CIVIL CONSTRUCTION DRAWINGS  
FOR  
STEAMBOAT BASECAMP  
LOT 1 WORLDWEST SUBDIVISION  
1901 CURVE PLAZA, STEAMBOAT SPRINGS, CO 80487

Steamboat Basecamp - Phase I

REVIEW SET  
NOT FOR CONSTRUCTION  
8/5/21

FIRE HYDRANT #1

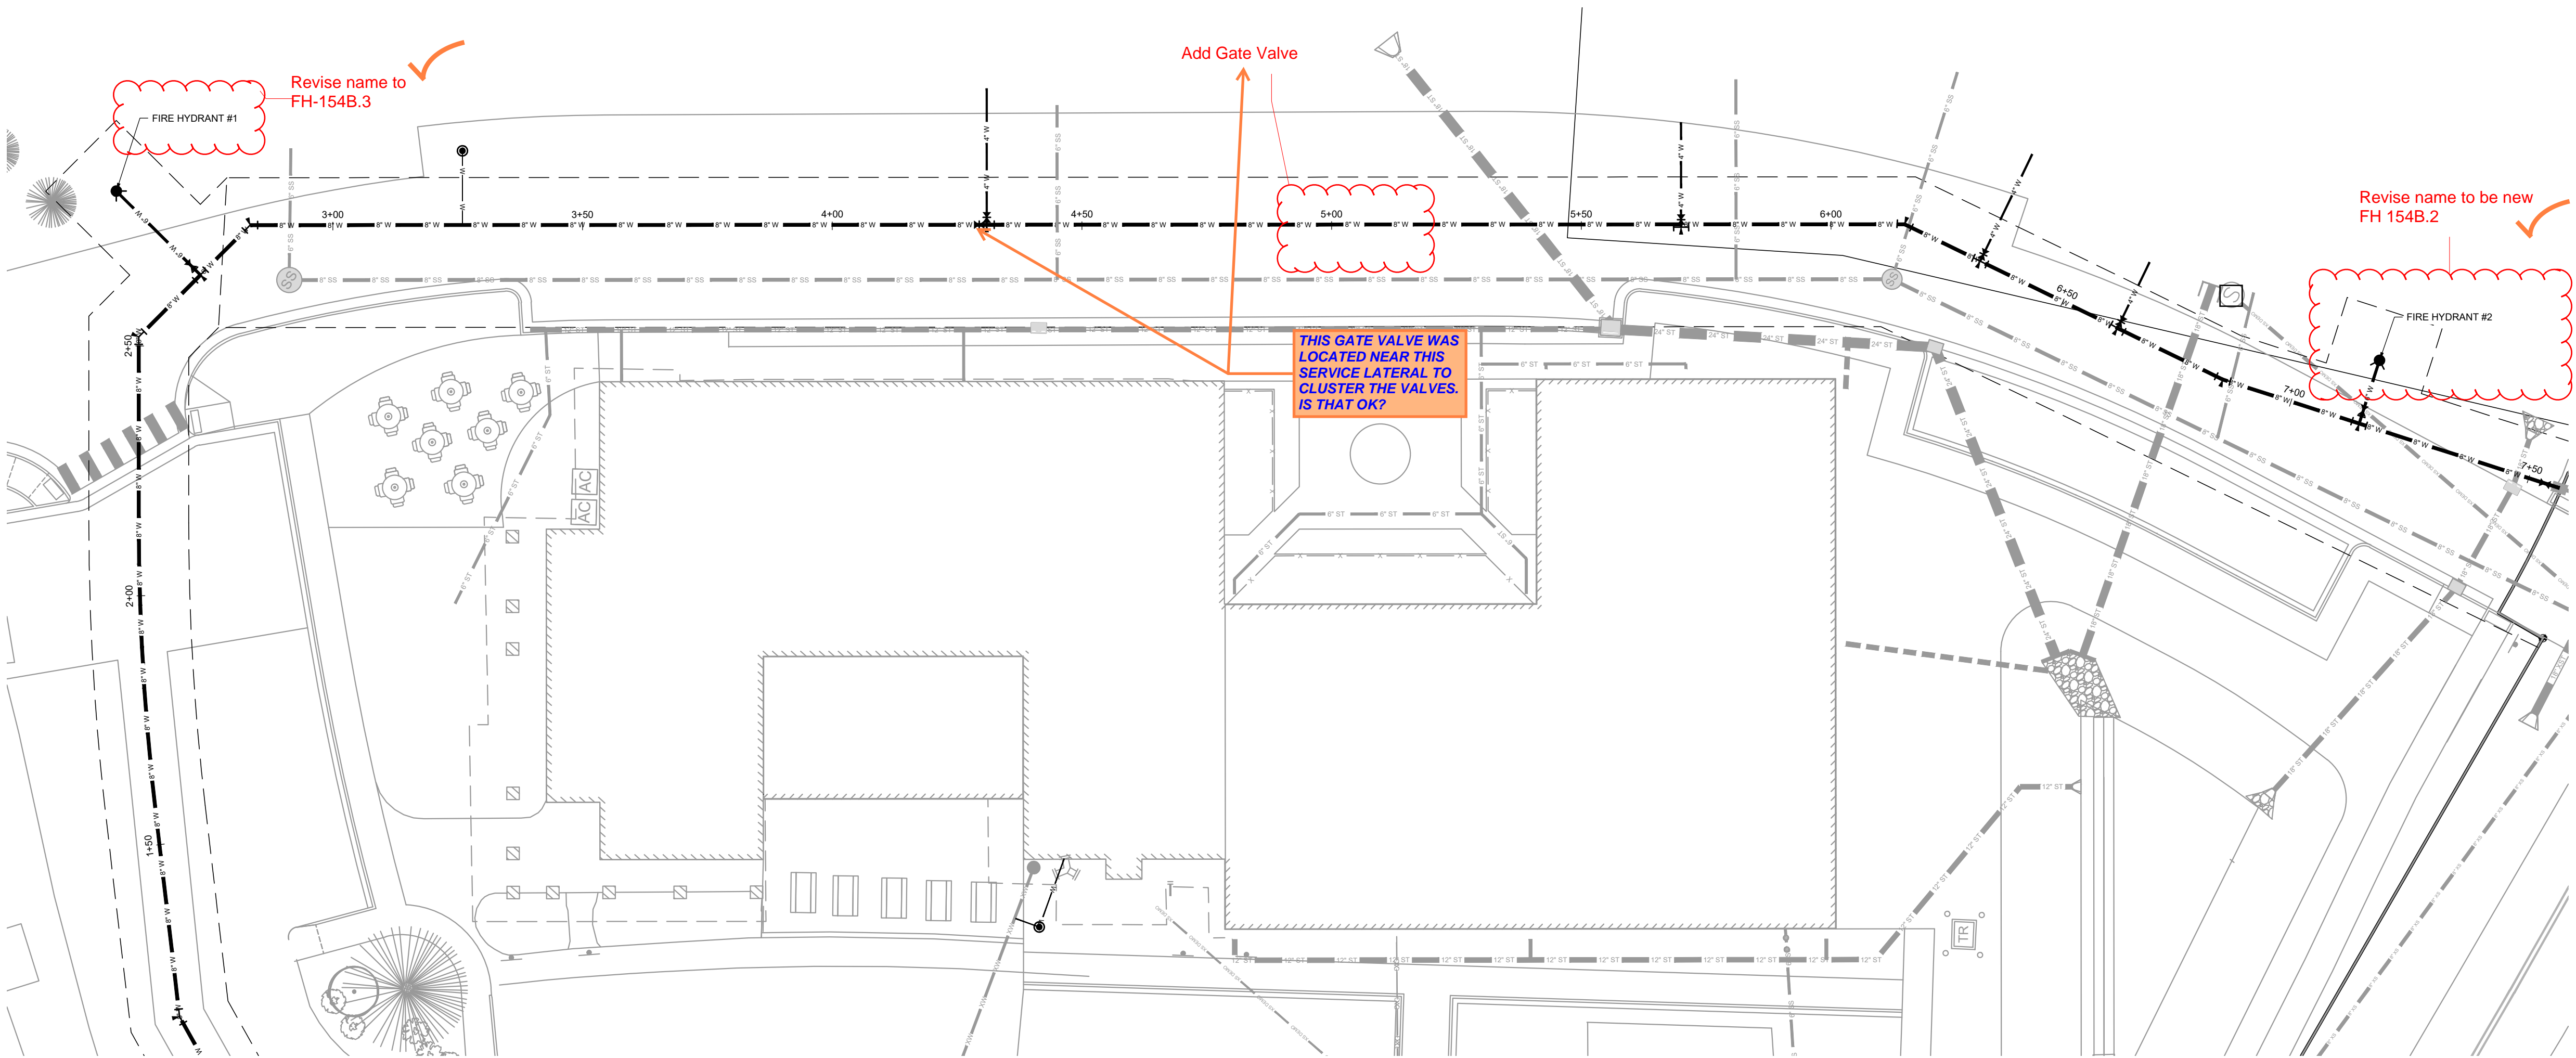
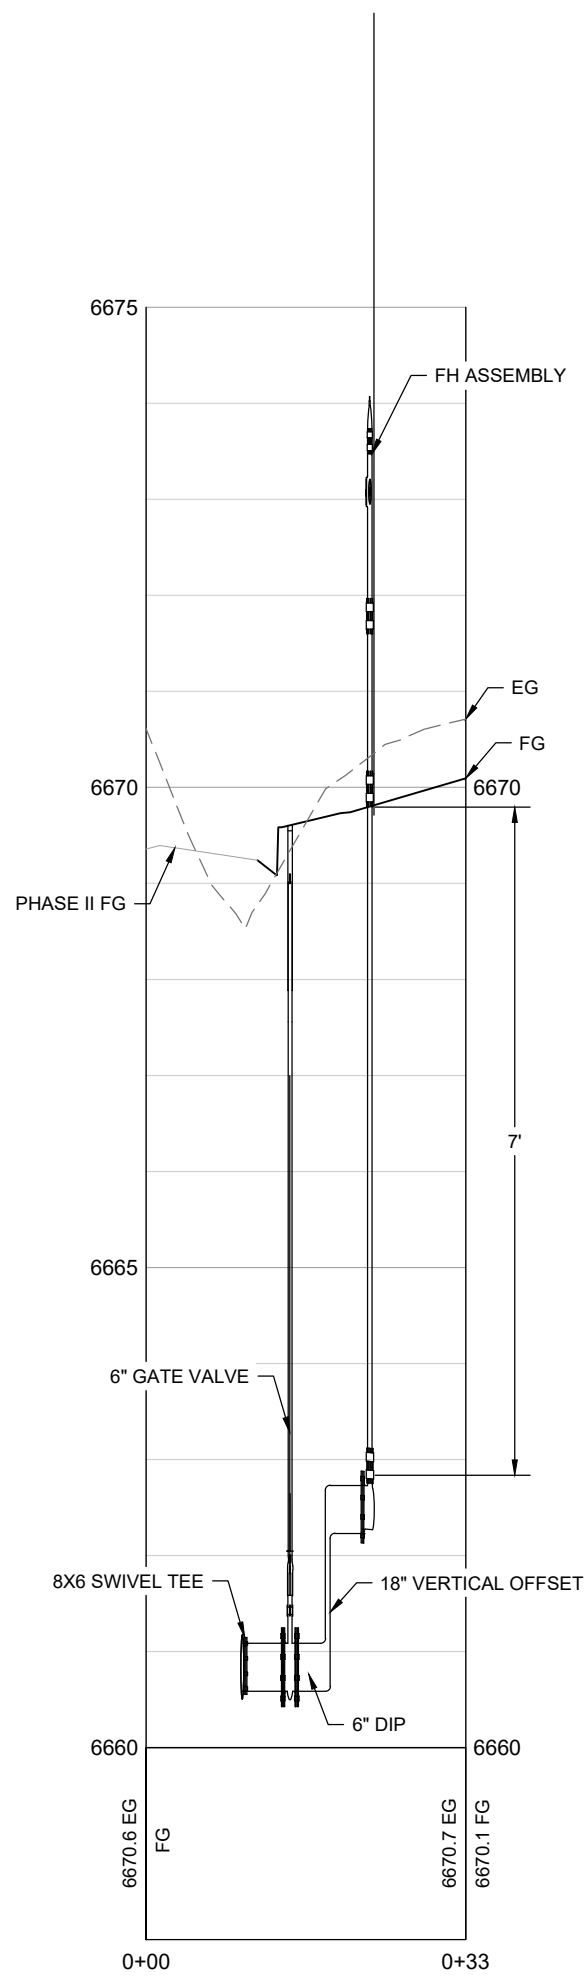
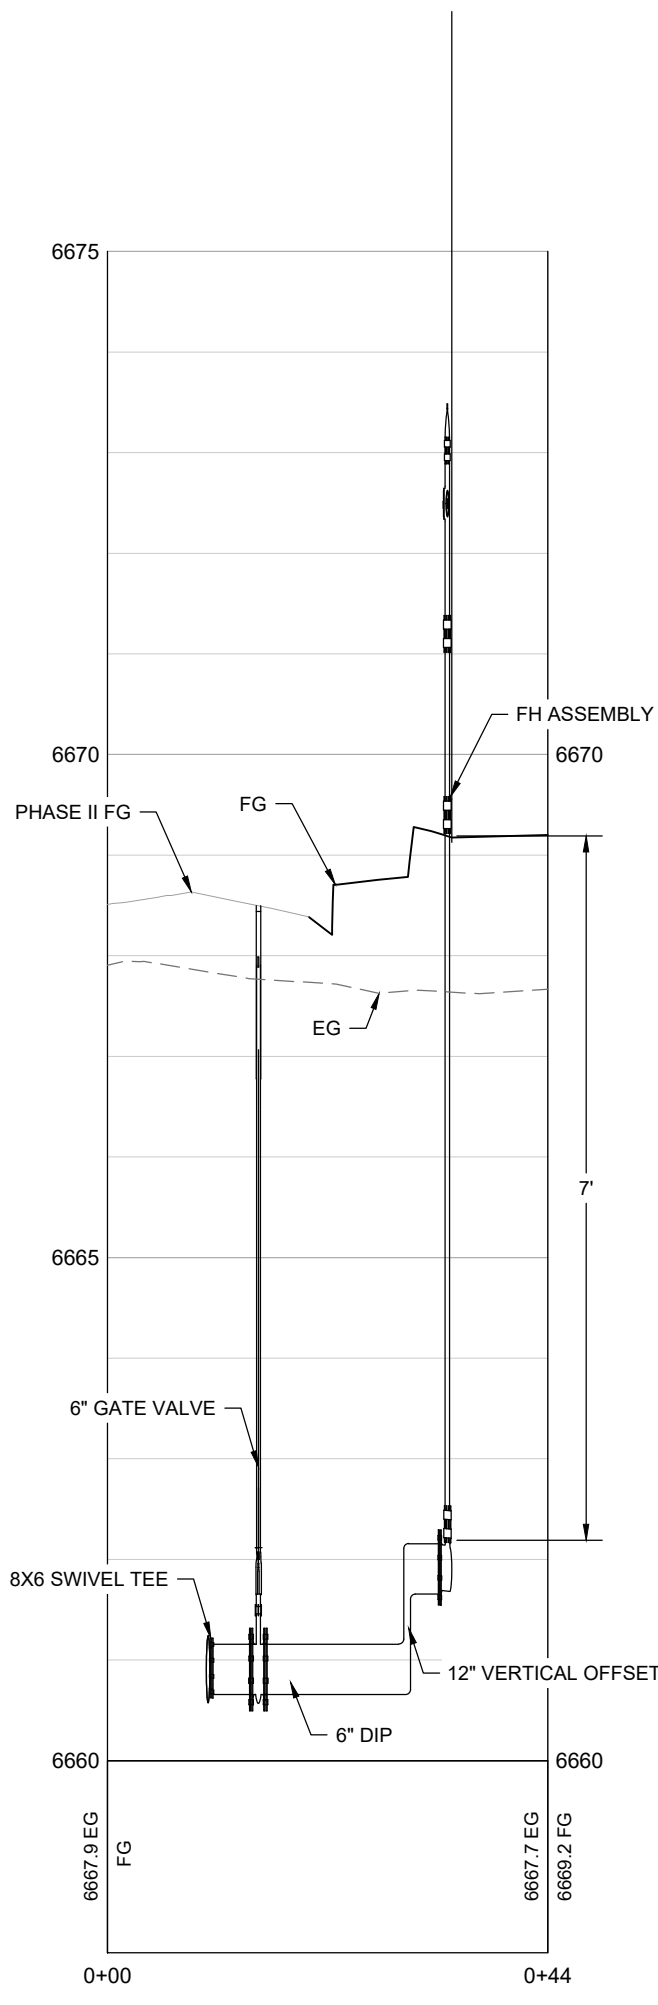
Is there a reason for the offsets to the fire hydrants in lieu of just having the FH be 8-8.5' deep? The slightly deeper FH would result in less fittings.

AGREED AND COMPLETELY UNDERSTAND. THE ORIGINAL ANTICIPATED SCHEDULE WAS TO TRY TO HAVE THE WATER IMPROVEMENTS INSTALLED THIS FALL AND LACK OF SUPPLIES REQUIRED READILY AVAILABLE OFFSET VS. A "CUSTOM" HYDRANT. THE 2022 INSTALL. ALLOWS TIME TO TRY TO PROCURE A SPECIAL HYDRANT.

SEWER MAIN PLAN & PROFILE (STA 0+00 - 5+04)

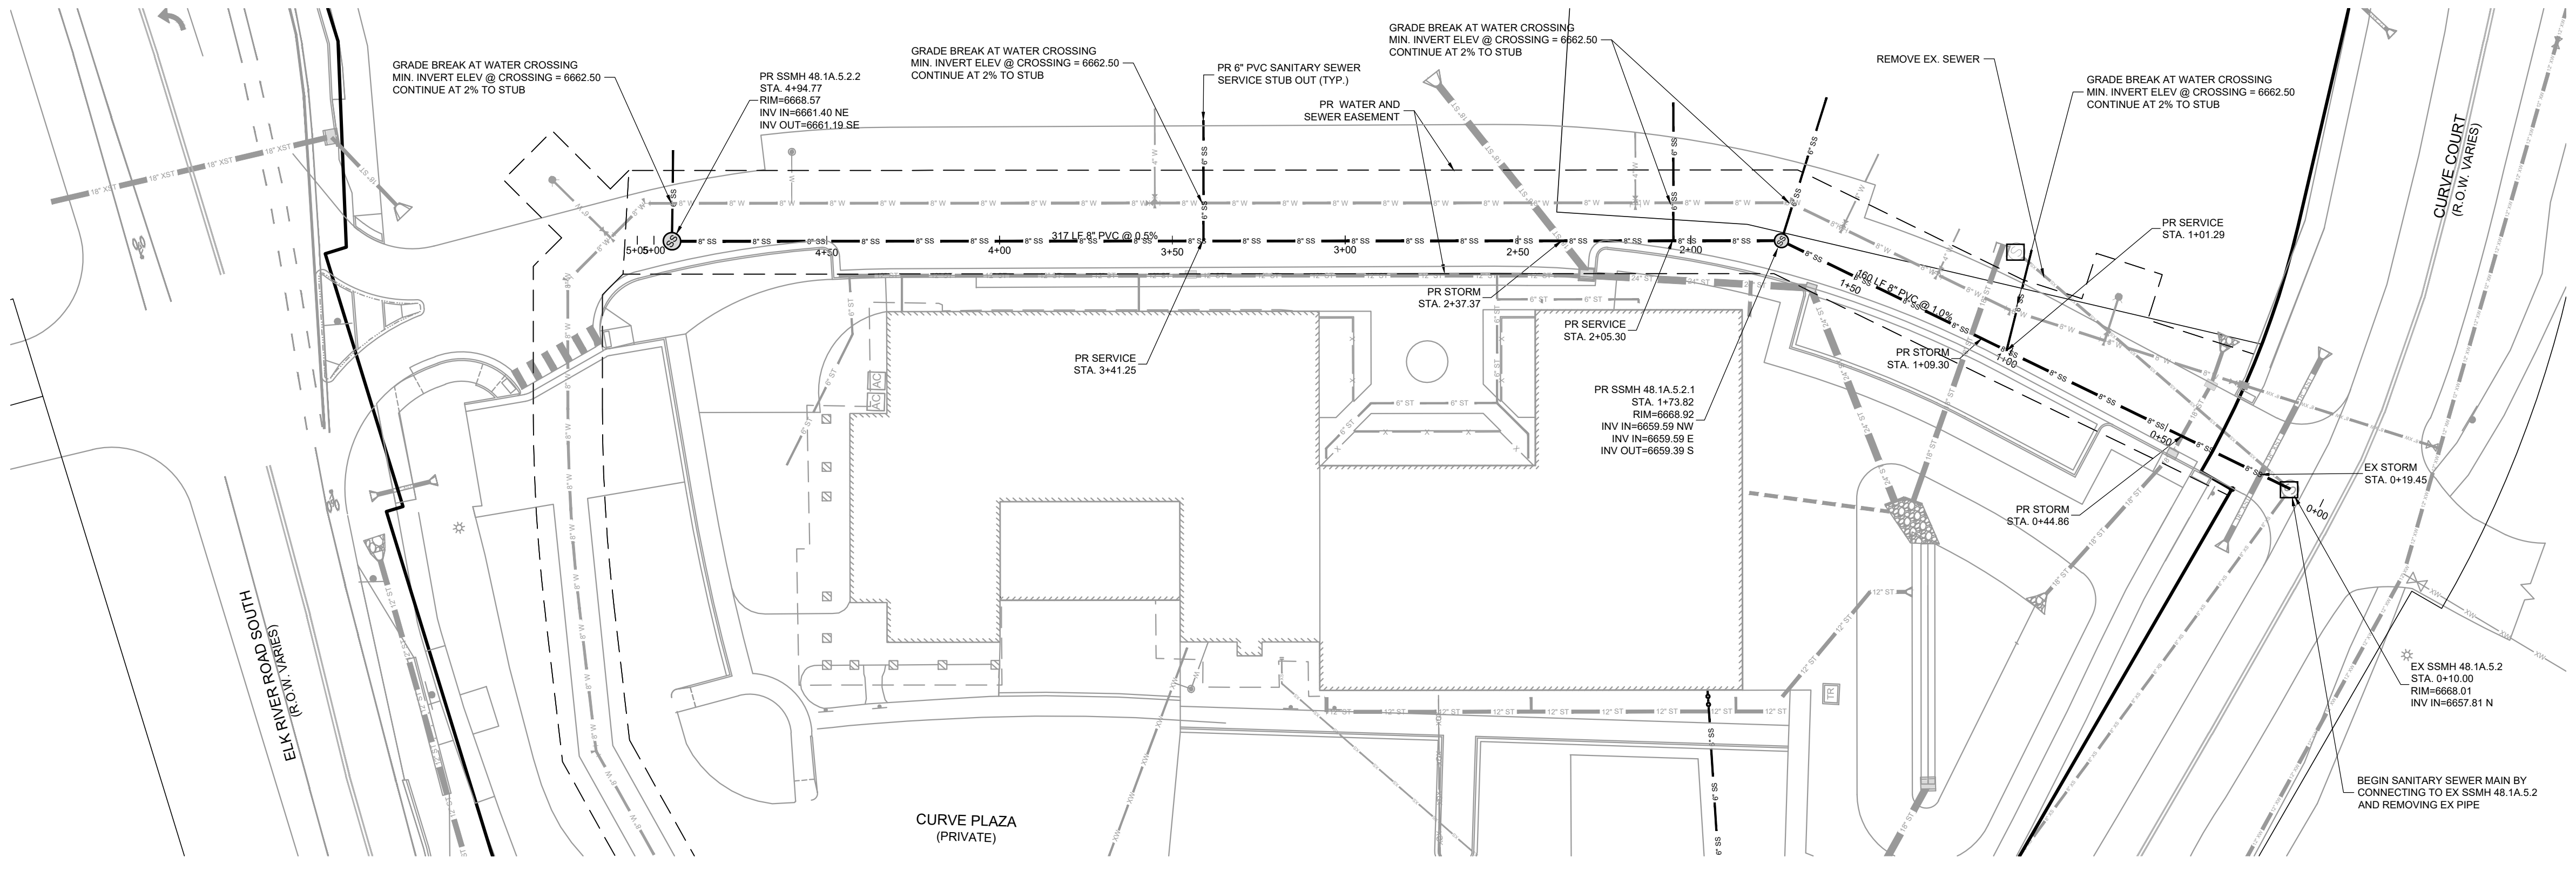
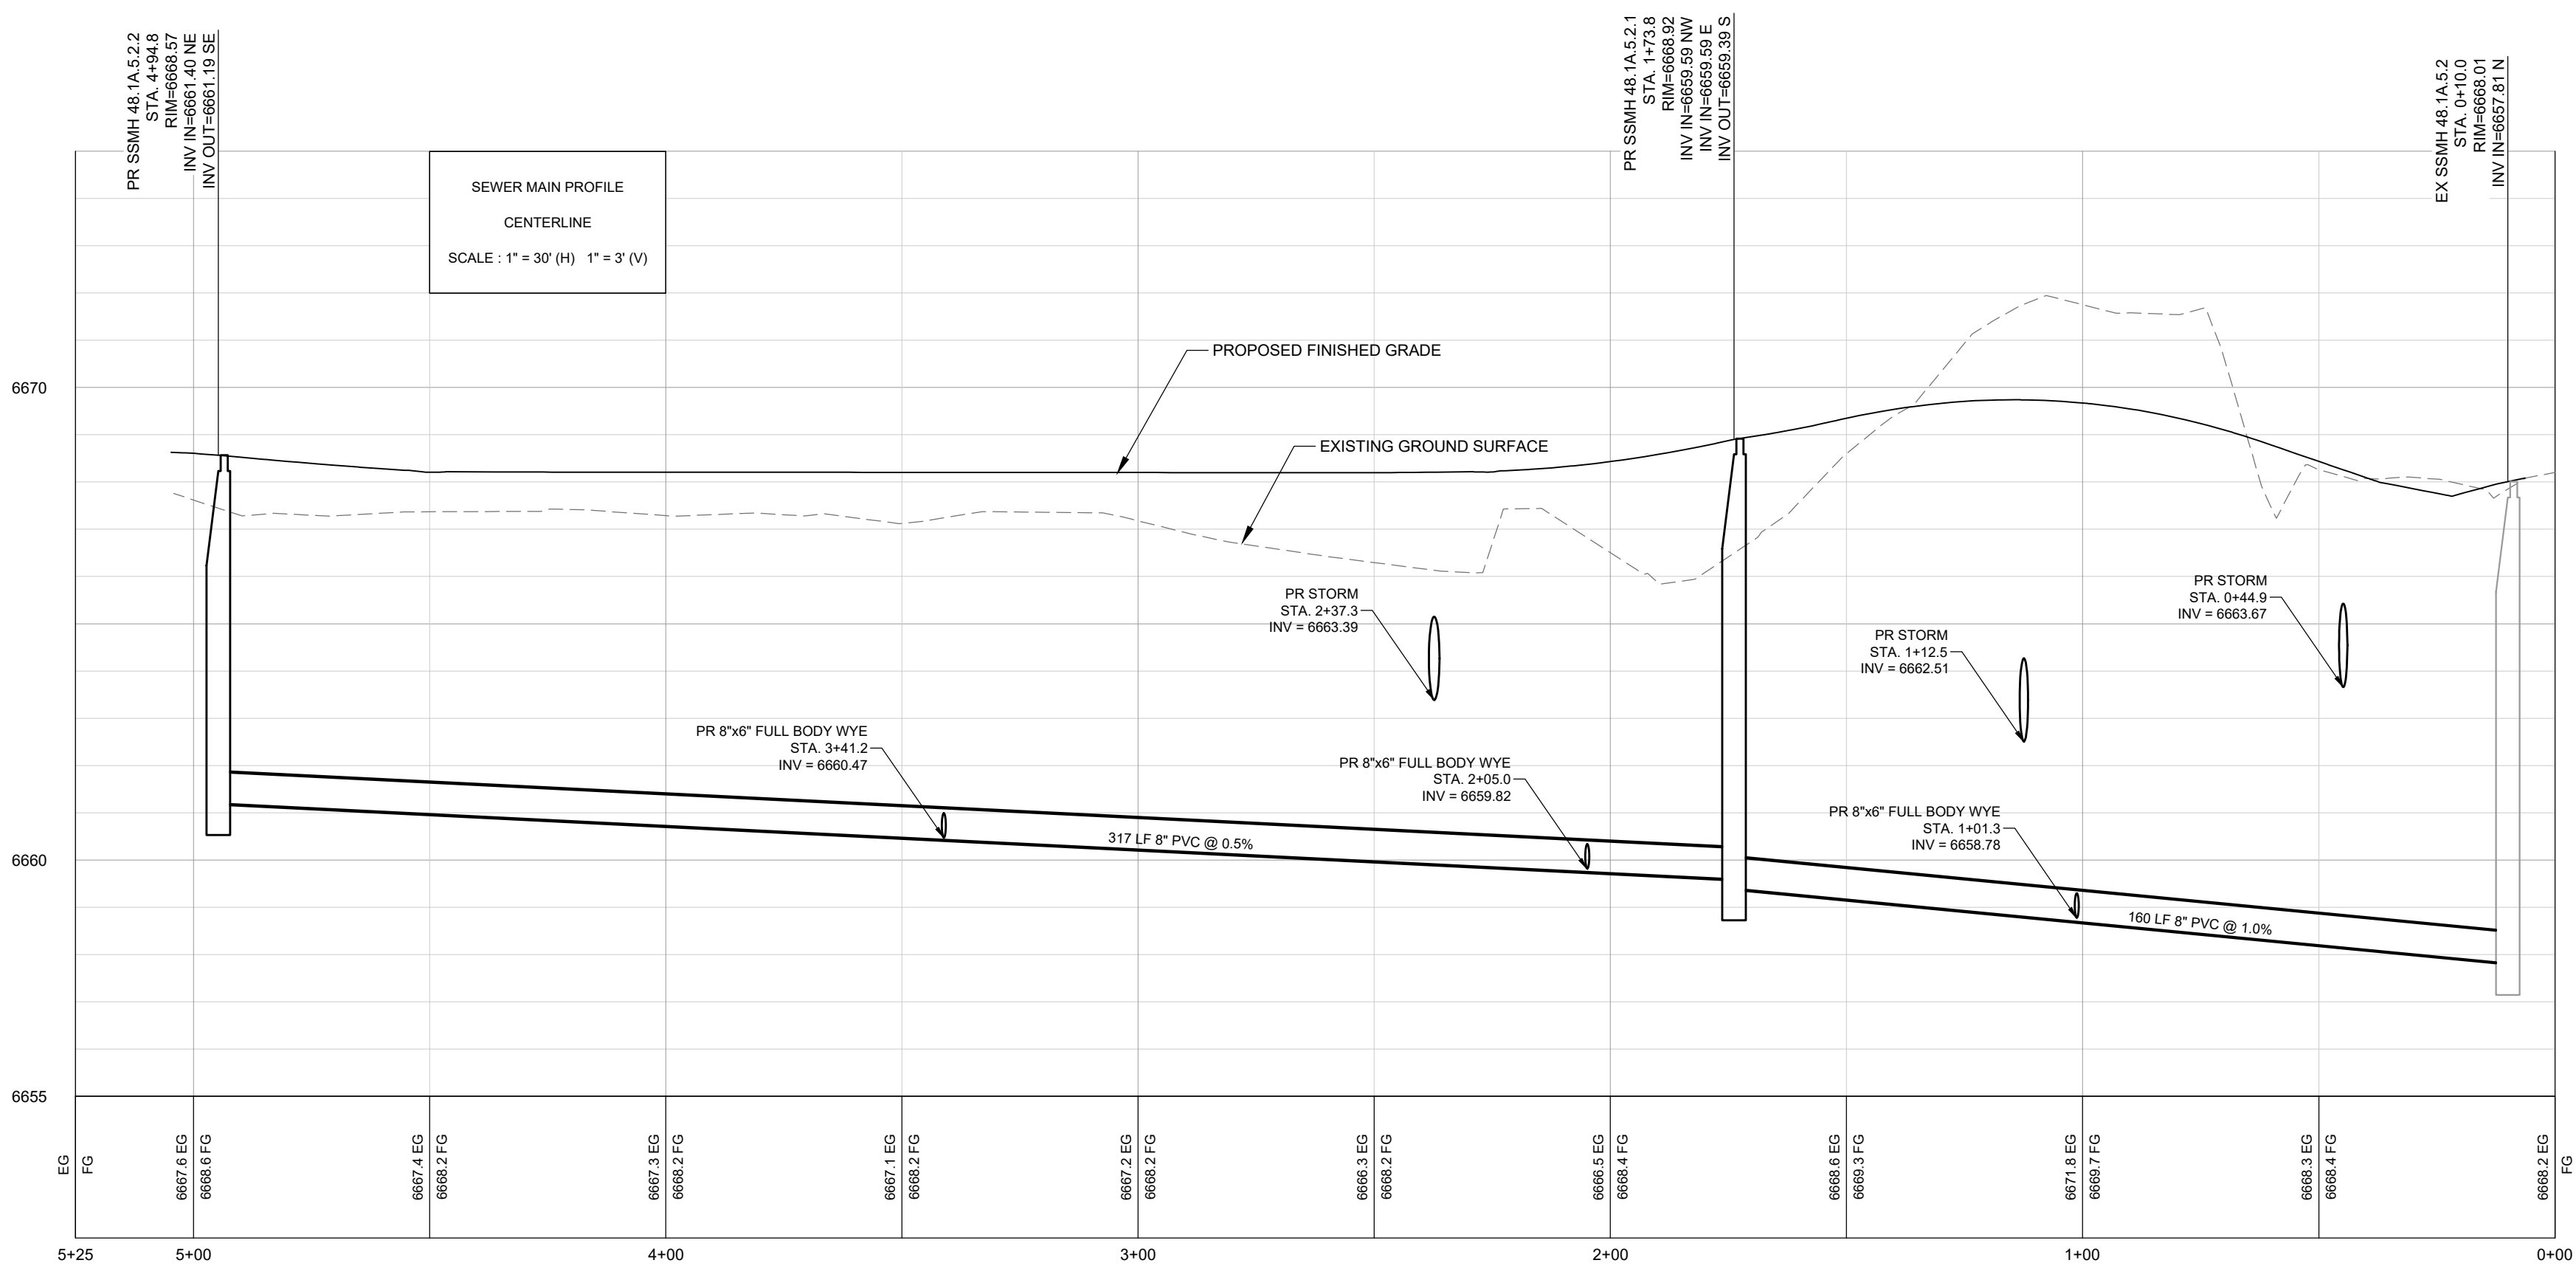
Remove this statement
